SWINGING BRIDGE REPORT

Re: Bridge Inspection: Coast Fork Willamette River Pedestrian Bridge

Subject: BRIDGE CLOSURE RECOMMENDATION

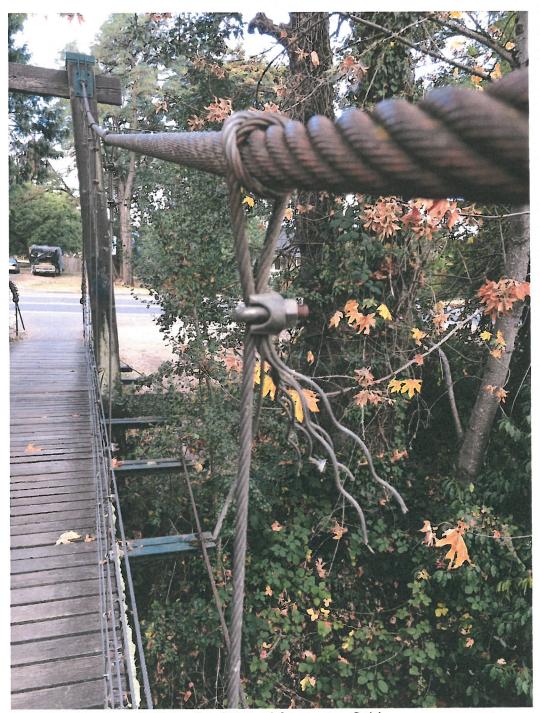
Photo 1 - Looking Ahead from West

Photo 2 - Looking Back from East

Photo 3 – Splayed Suspension Cable

Photo 4 - Decayed Floorbeam Bent 2

Photo 5 – Underside of Deck

Photo 6 – Overhead Powerlines Span 3

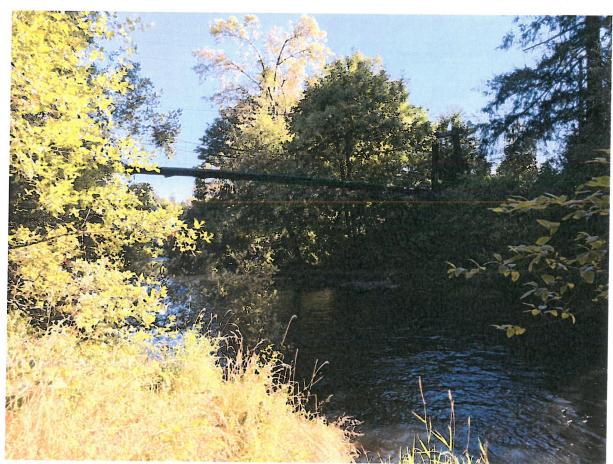
Photo 7 - Looking East

Photo 8 - Decayed Column

Photo 9 – Typical Suspender to Deck Connection

Photo 10 – Corroded Suspender Cable
